WORKPLAN
for a
SOIL AND GROUNDWATER ASSESSMENT
a t
The Salvation Army
810 Clay Street
Oakland, California

Re: WORKPLAN ADDENDUM
The Salvation Army
810 Clay Street
Oakland, CA 94604

Figure 2

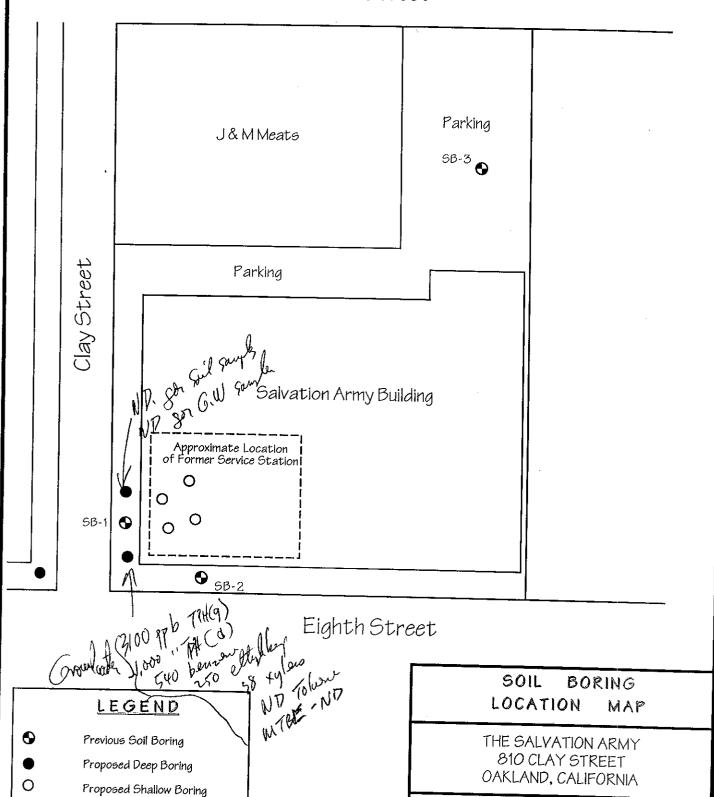
This letter presents an addendum to ASE's March 31, 1999 workplan for the above-referenced site. Per our telephone conversation on April 2, 1999, you requested that one additional boring be drilled across the street from the site in the anticipated downgradient direction. Attached, please find a map showing the proposed additional boring location. If you have any questions or have any other comments or concerns, please feel free to call me at (925) 820-9391.
